寄件者: 陳灝然
寄件日期: 2025年08月03日星期日 22:59
收件者: tpbpd/PLAND
副本: Peter Pak Lun NGAN/PLAND
主旨: A/NE-LYT/841 補充資料
附件: 31064-R01-02.pdf
類別: Internet Email

Traffic Impact Assessment for Section 16 Planning Application A/NE-LYT/841 for Proposed Temporary Open Storage of Construction Materials and Machineries with Ancillary Facilities for a Period of 3 Years and Associated Filling of Land at Various Lots in D.D. 83, Lung Yeuk Tau, New Territories

TRAFFIC IMPACT ASSESSMENT REPORT

Reference: 31064-R01-02

FIGURE 3.3

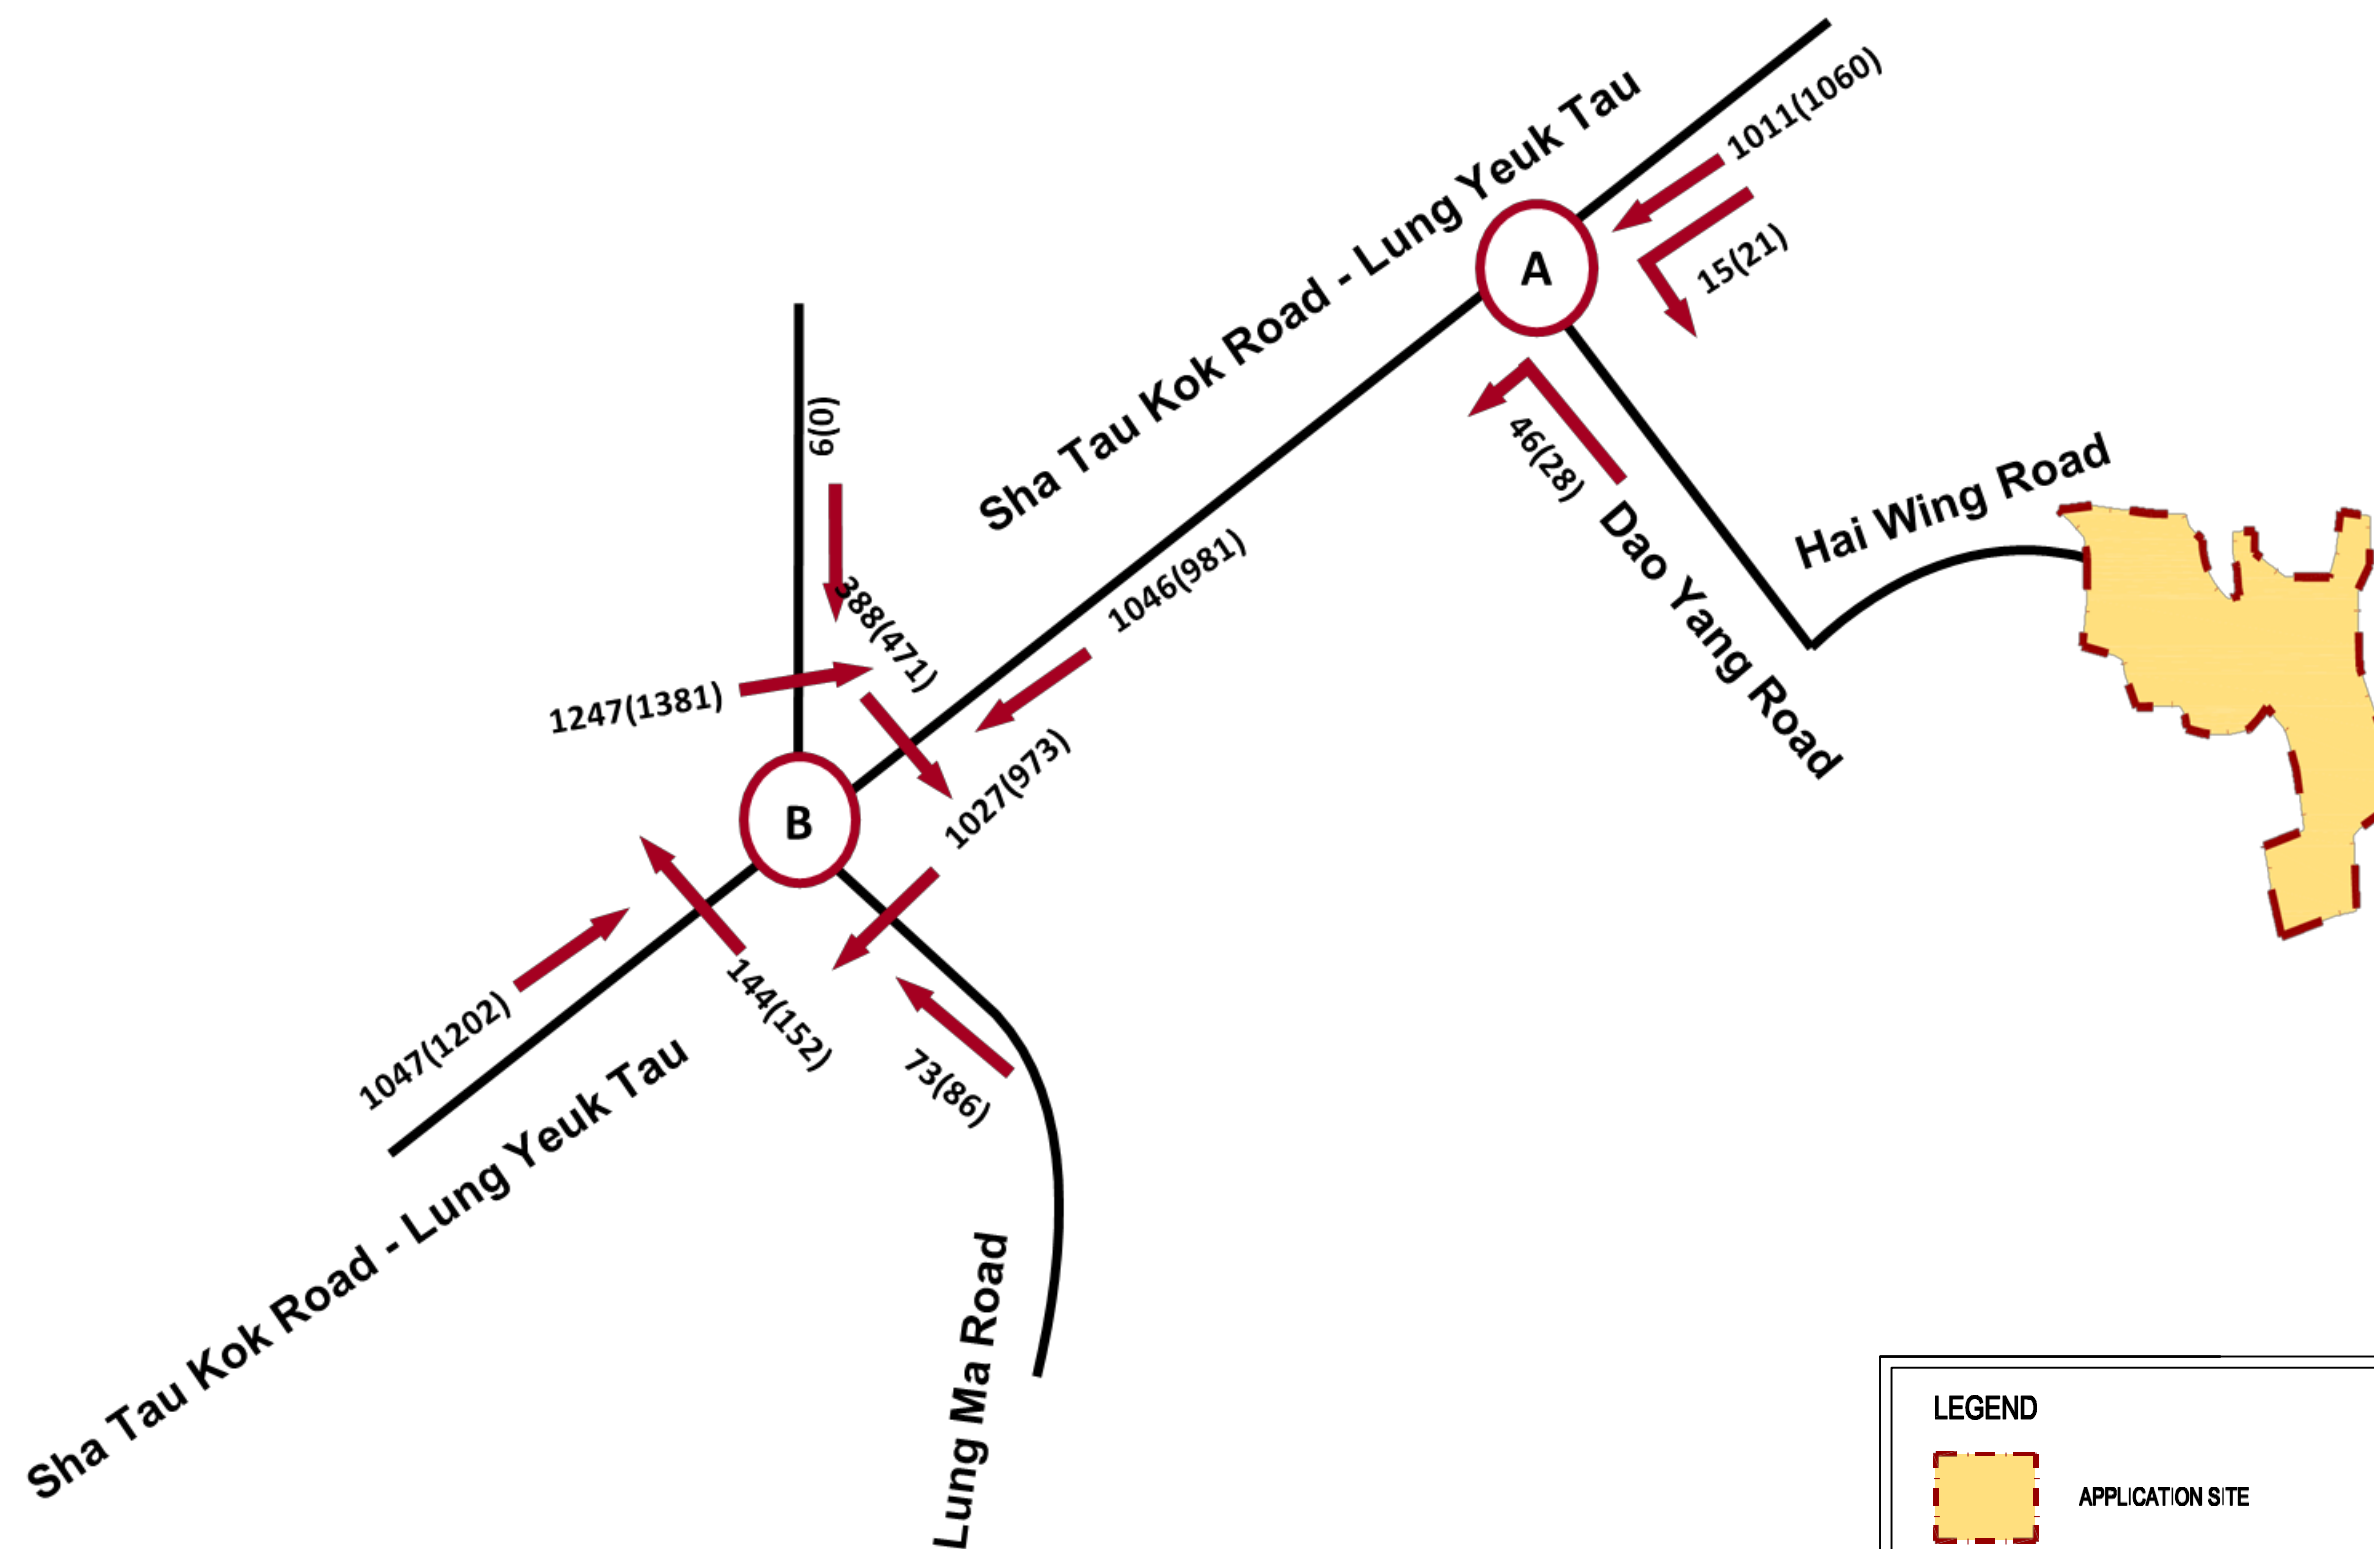
8	<p>(31.7.2025)</p> <p>Figure No. 3.3: It was stated in Section 3.3 that the traffic count was done in 2025. The applicant should review whether this figure is for Year 2025 observed traffic flow instead.</p>	<p>(1.8.2025)</p> <p>The traffic count survey was conducted in June 2025 and reflects the observed traffic conditions during the operational hours of the proposed development. The assessment figures have been reviewed and updated, and the caption has been revised to clearly state “2025 Observed Traffic Flow.” The updated figures are presented in the revised submission.</p>
9	<p>(31.7.2025)</p> <p>Figures Nos. 4.1 and 4.2: The applicant should review whether the additional flows caused by trip generation and trip attraction had been reversed. The applicant should also review whether these figures are for the traffic flows in the completion year (Year 2028) instead.</p>	<p>(1.8.2025)</p> <p>The trip distribution has been reviewed, corrected, and the figures have also been updated to ensure proper directional flow. Both figures now represent the forecast traffic for Year 2028, with Figure 4.1 showing the 2028 Reference Flow and Figure 4.2 showing the 2028 Design Flow (including development traffic).</p>

FIGURE 5.1

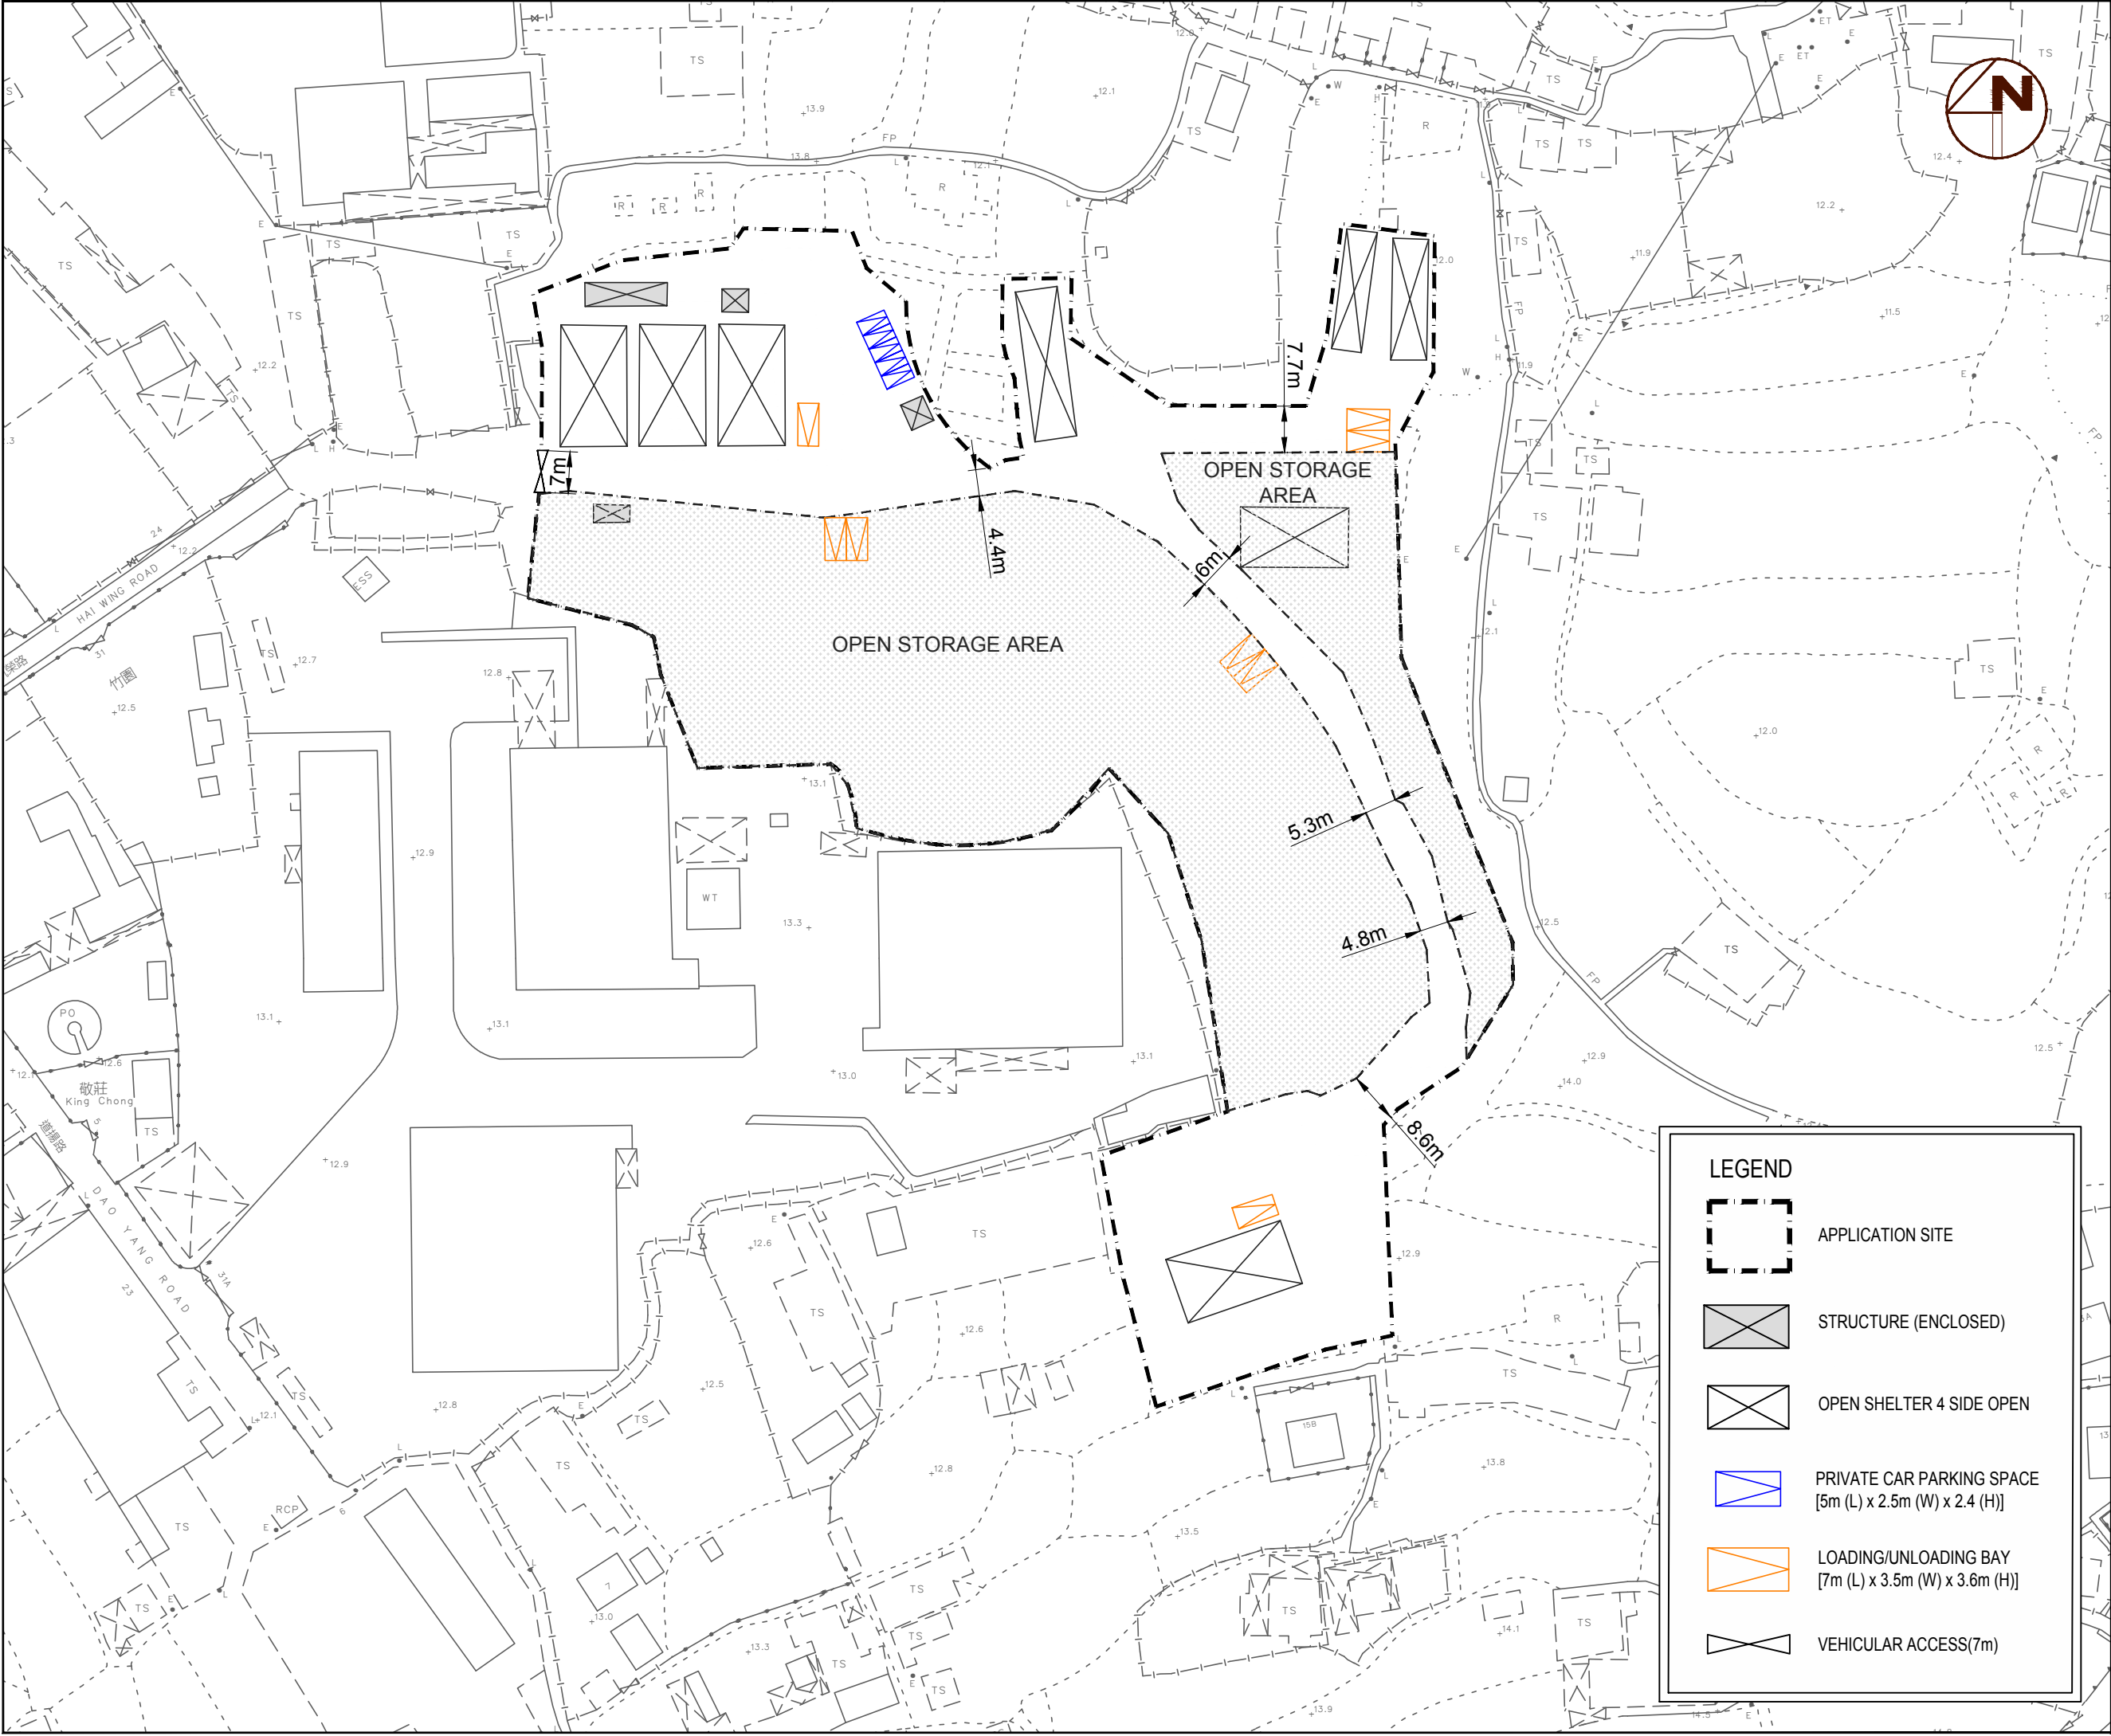
10	<p>(31.7.2025)</p> <p>Figure 5.1: The applicant should indicate the dimensions of driveways in the Site and the widths of the village roads leading to the Site. The applicant should also advise whether there will be any gate installed at the entry. If so, the applicant should ensure such arrangement will not cause queuing of vehicles outside the Site.</p>	<p>(1.8.2025)</p> <p>The internal driveway within the Site is intended to be designed with a width of approximately 7.0 metres, for light goods vehicle access and maneuverability. The connecting village road has a minimum clear width of approximately 4.4 metres, which is considered adequate to accommodate the anticipated low-volume light goods vehicle traffic under an appointment-based access arrangement. This road section has been previously used by similar vehicles and is not expected to result in any capacity or safety issues given the low traffic volume and controlled access.</p>
